CUSTOMER:		PROJECT:		LOCATION:		DESCRIPTION:	
		P-3191 SOF SUSTAINMENT TRAINING COMPLEX				SHOOT HOUSE B-CATWALK FRAMING PLAN	
NO. DATE:		DESCRIPTION:		DATE:		DRAWN BY: VM	
		REVISIONS		PRINT RECORD		DATE: 10/05/2015	
						JOB NO. 0407	
						SHEET NO. 3E1

REV.	DESCRIPTION	DATE
1	For Field Use	12/01/2015
PROJECT NAME: DESIRE STREET MINISTRIES		
LOCATION:		
CONTR:		
DRAWN BY: AK		
DATE: 12/01/2015		
CHECKED BY: PM		
JOB NO.		
ROOF FRAMING PLAN		
SHEET NO. E1

B	02/18/2015	CB	MSB	FOR APPROVAL	
NO.	DATE	BY	CHK'D	REVISION	
PAINT SPEC.: <i>One Coat Shop Primer</i>					
REFERENCE DRAWINGS: <i>Structural Design Set</i>					
GUARDIAN AMBULANCE BUILDING					
CUSTOMER					
HOLE DIA.	13/16 Ø U.N.	DRAWN BY:	CB	P.O.#	Structural Design Set
NET. SPEC.	A36 U.N.	CHECKED BY:	MSB	DATE	02/18/2015 W.O.# -
EJECTION DWG.	E8	24"x36" Sht Sz. PLOT SCALE	1:24	SHT. #	E10
		NTS			REV. B

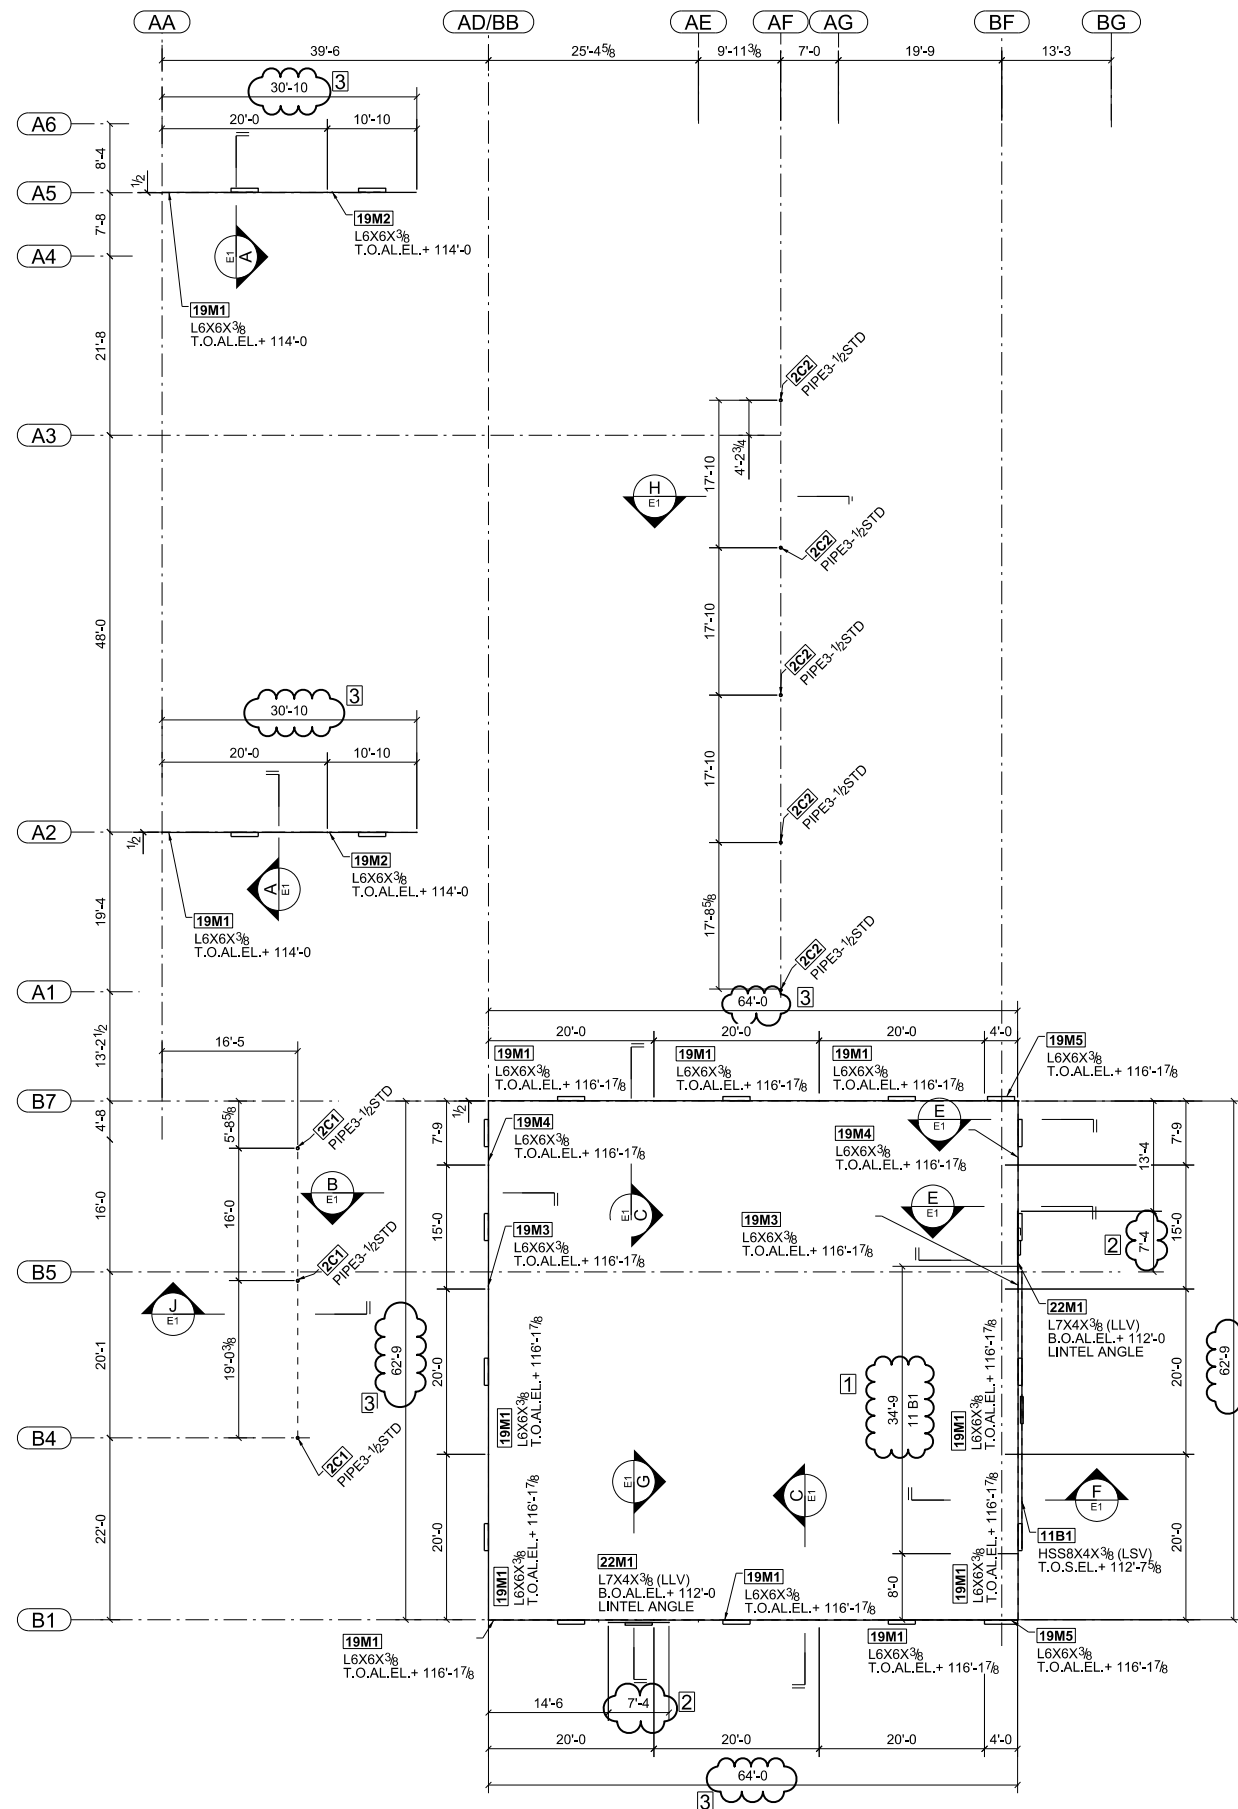
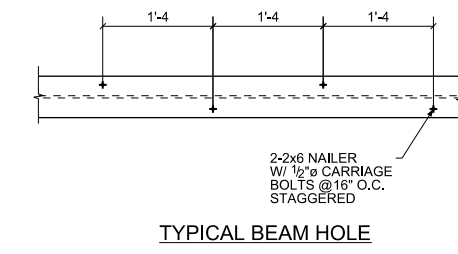
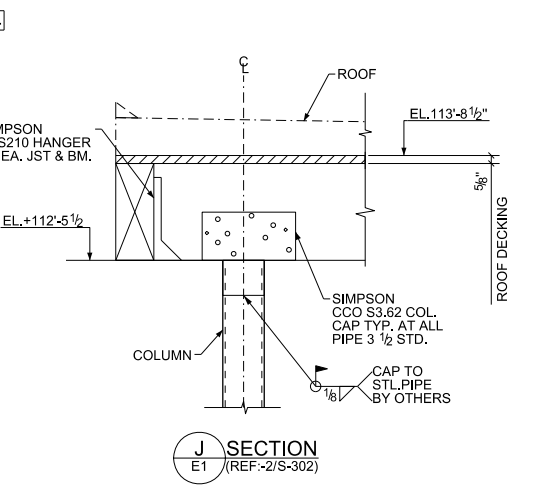
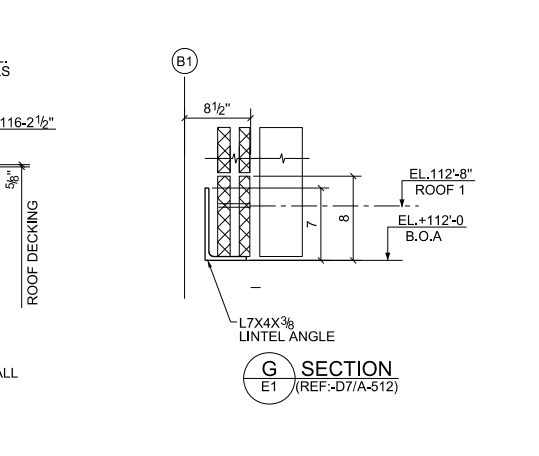
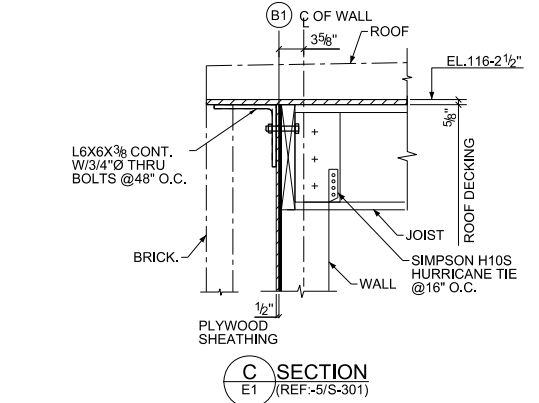
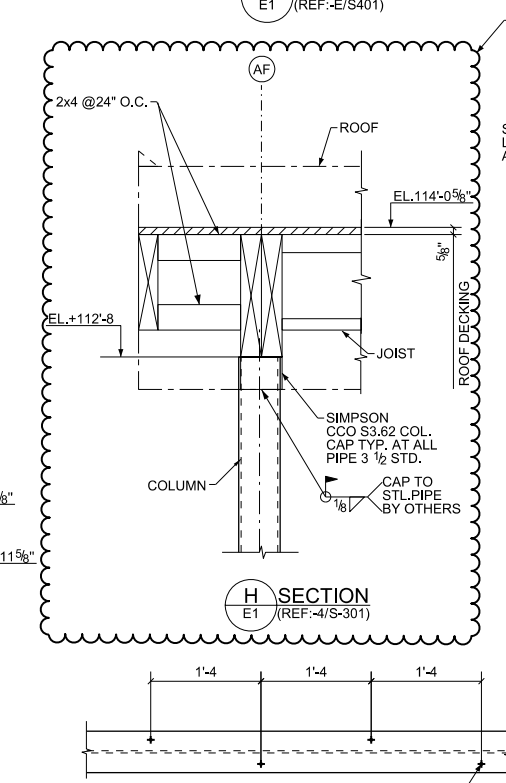
GC TO VERIFY AND CONFIRM BEFORE ERECTION

- 1 11B1 BEAM LENGTH (REFER RFI#02)
- 2 LINTEL ANGLE LENGTH (REFER RFI#03)
- 3 L6X6X3/8 ANGLE LENGTH (REFER RFI#03)
- 4 SECTION H/E1 (REFER RFI#04)

For Field Use	12/01/2015
REV.	DESCRIPTION	DATE
PROJECT NAME: DESIRE STREET MINISTRIES		
LOCATION:		
CONTR:		
DRAWN BY: AK	DATE: 12/01/2015	CHECKED BY: PM
NO.	SECTIONS & TYPICAL DETAILS	SHEET NO. E4

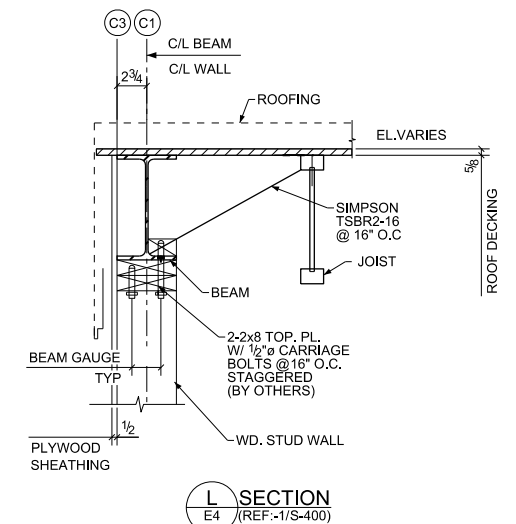
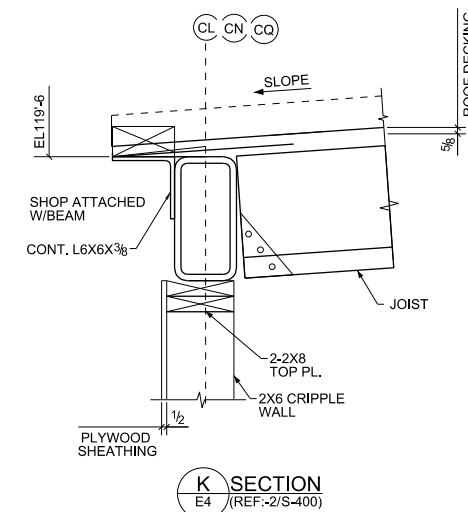
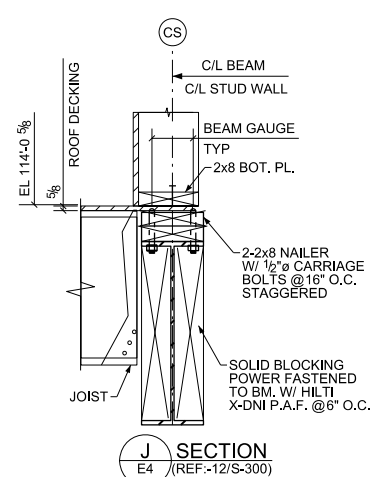
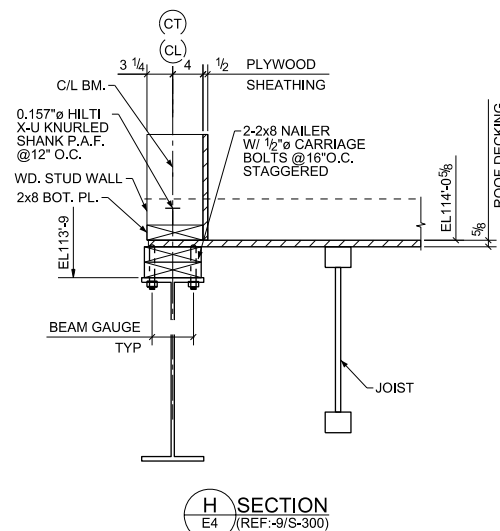
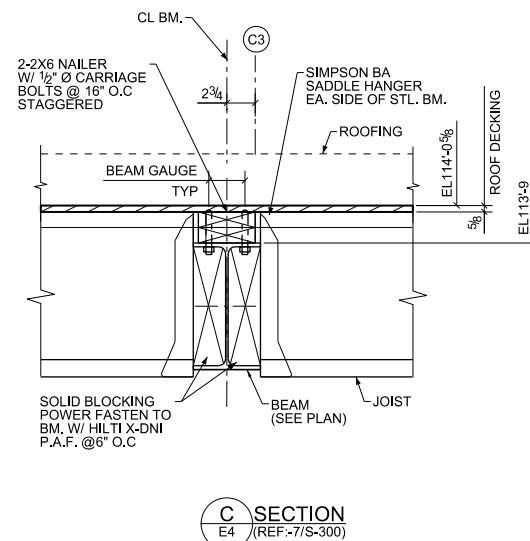
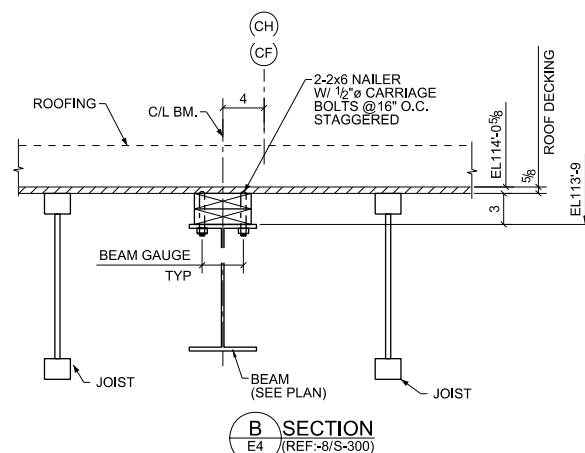
GC TO VERIFY AND CONFIRM BEFORE ERECTION:

- 1 STIFFNER PLATE NOT POSSIBLE TO PROVIDE INTO THE HSS COLUMN PER APPROVER COMMENT. HENCE STIFFNER PLATE DID NOT PROVIDE INTO THE HSS COLUMN. (REFER RFI # 05)

ROOF FRAMING PLAN.
REF: (S6.1)
(TOP OF ROOF ELEVATION VARIES U.N.O.)
(TOP OF STEEL ELEVATION VARIES U.N.O.)

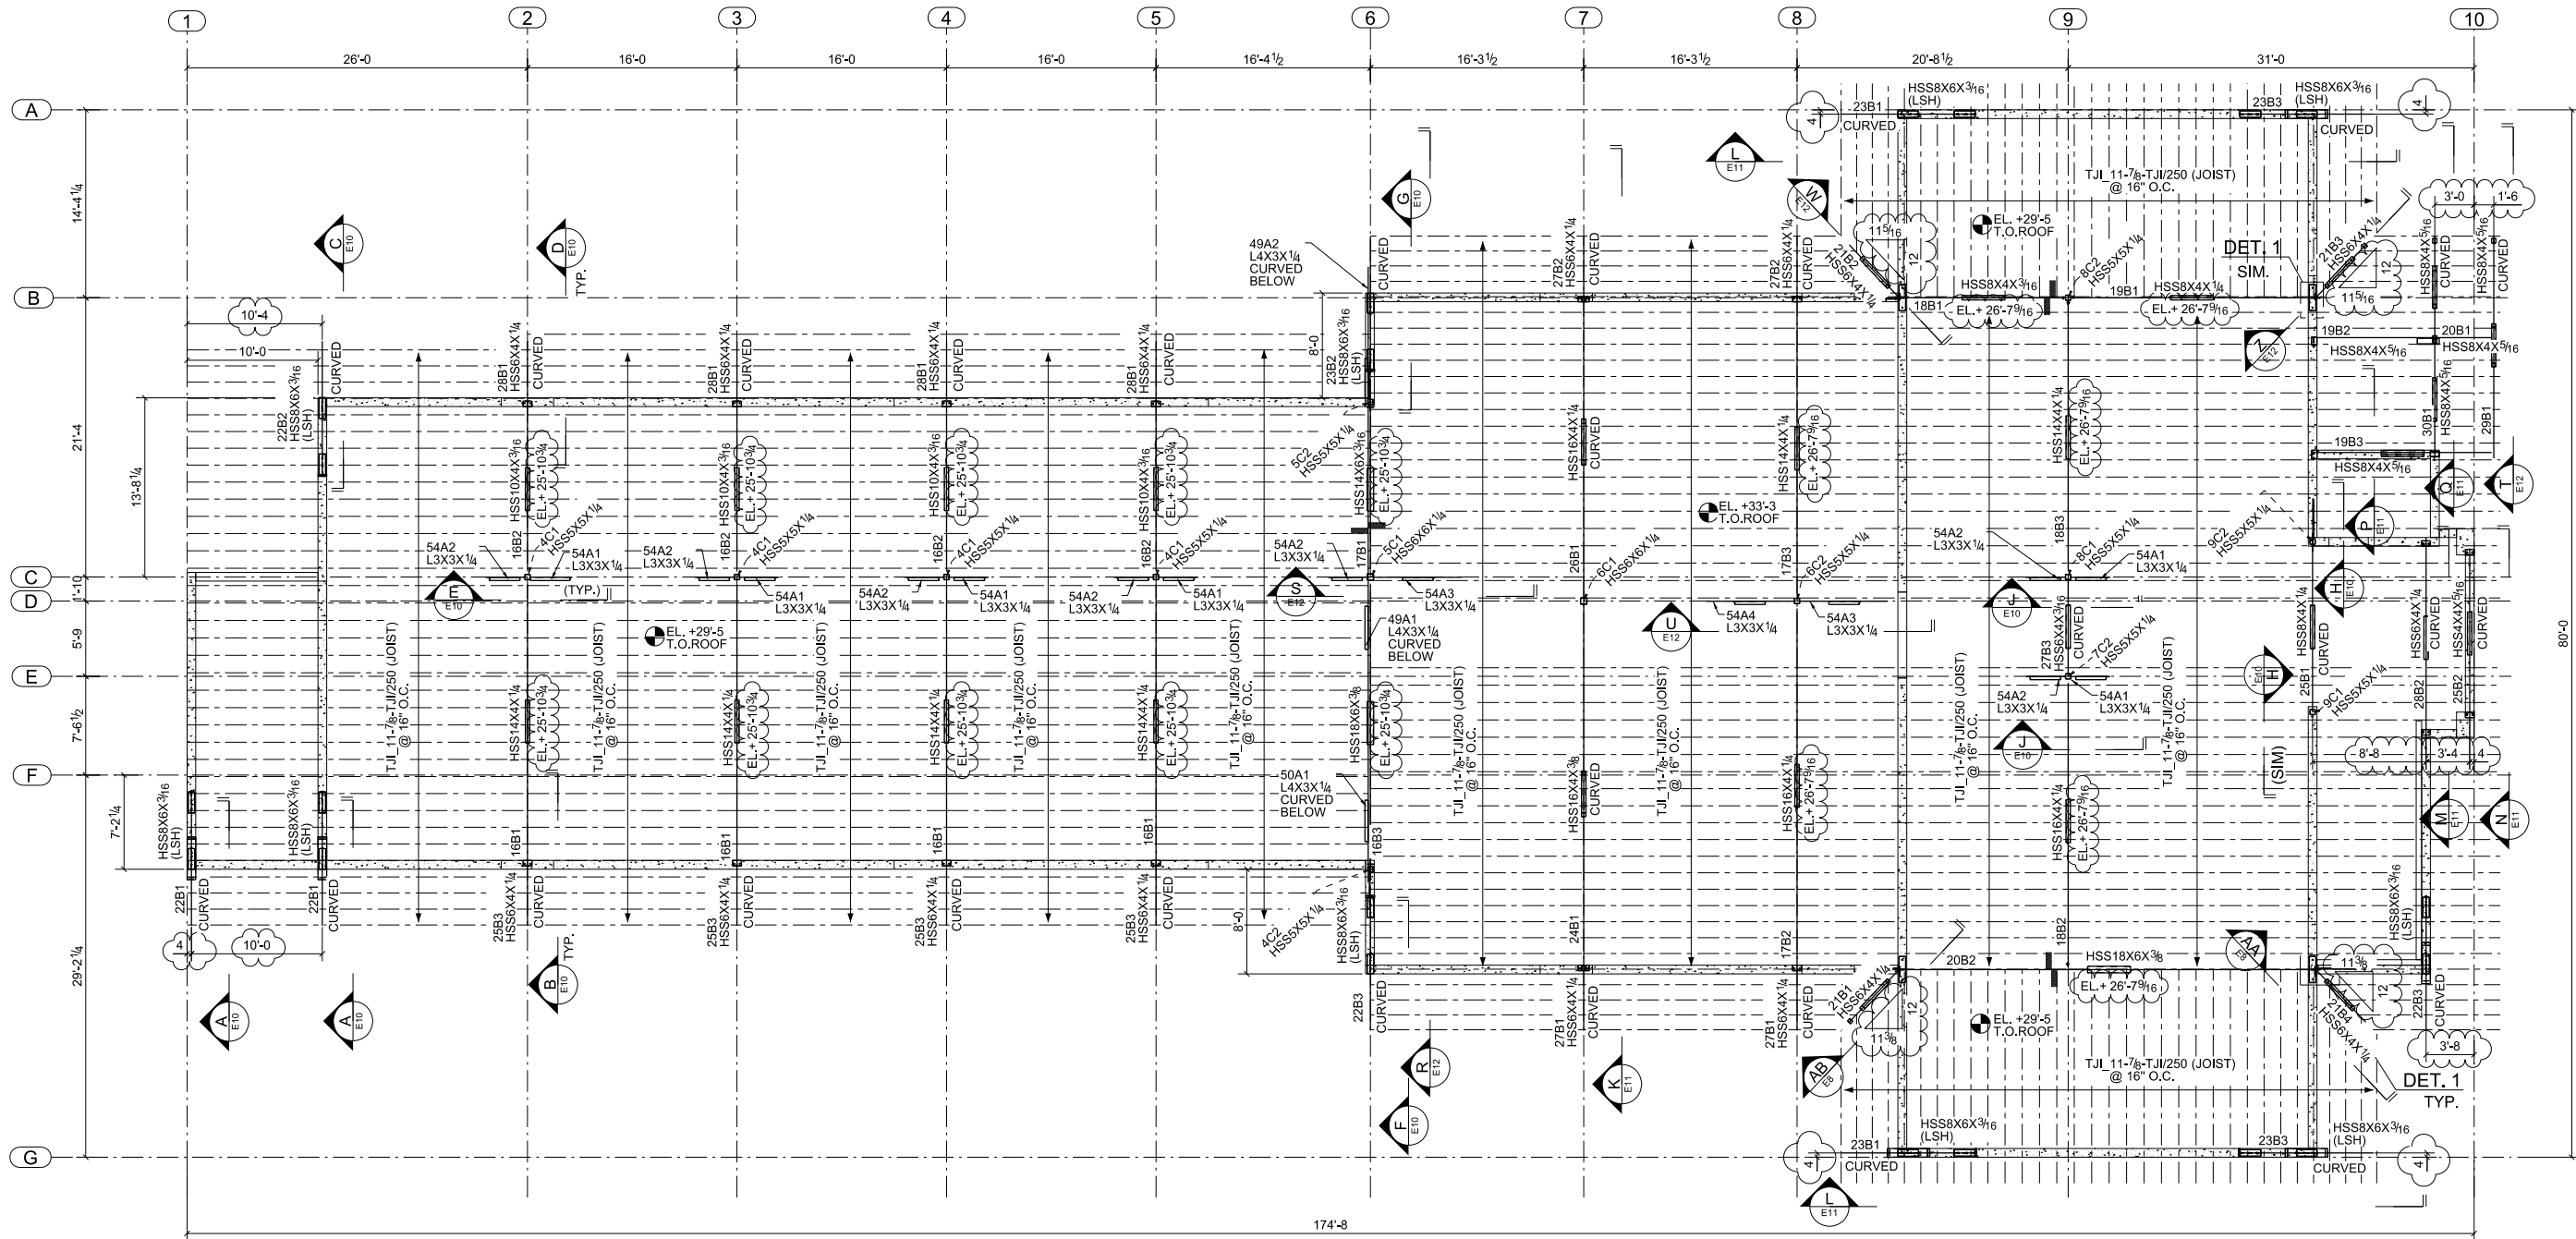
APPROVER TO VERIFY ALL
CLOUDED PORTION.

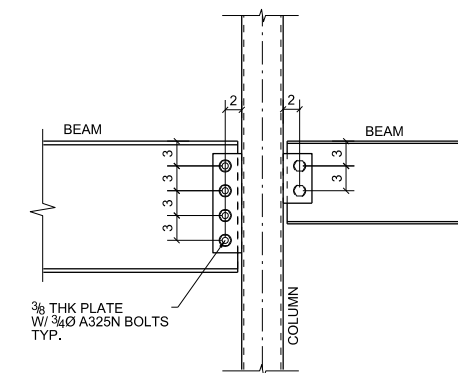
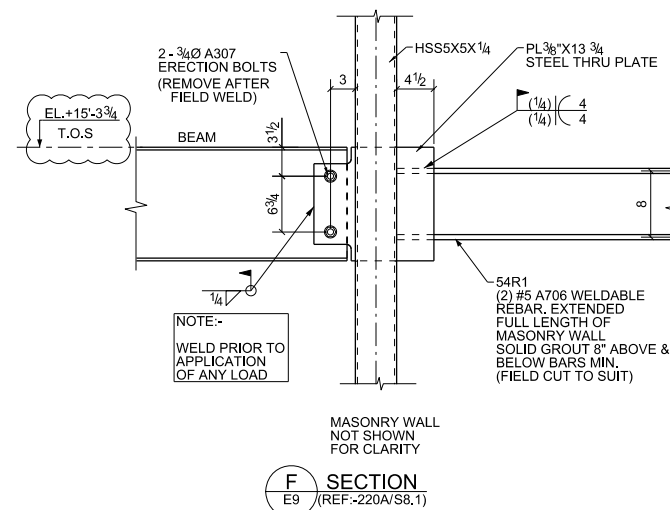
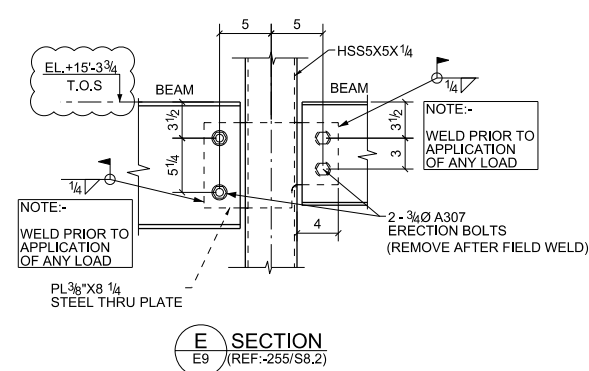
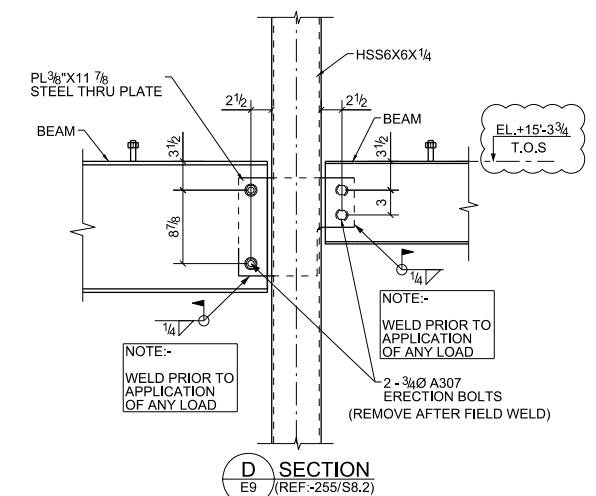
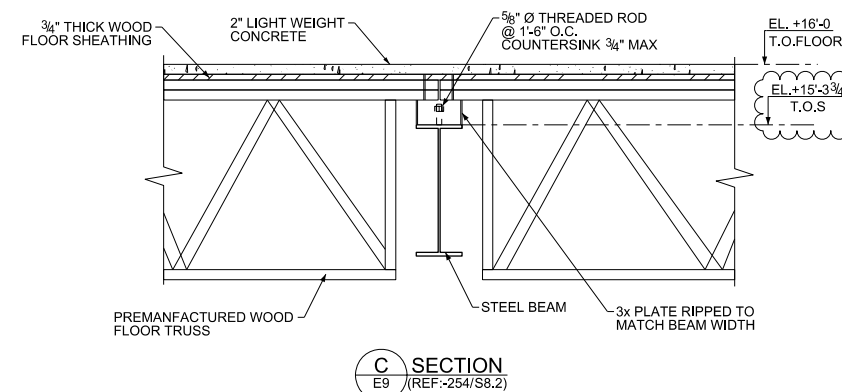
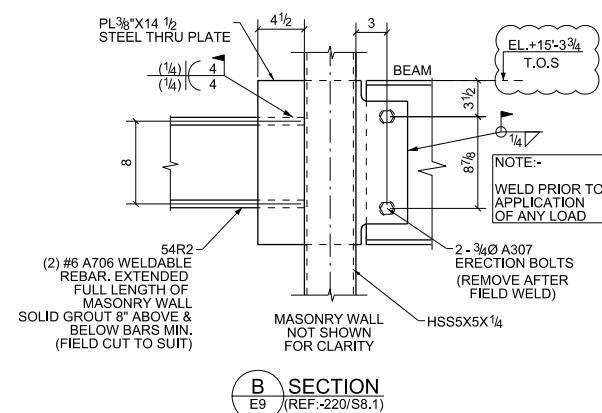
APPROVER TO VERIFY
ALL CLOUDED PORTION.
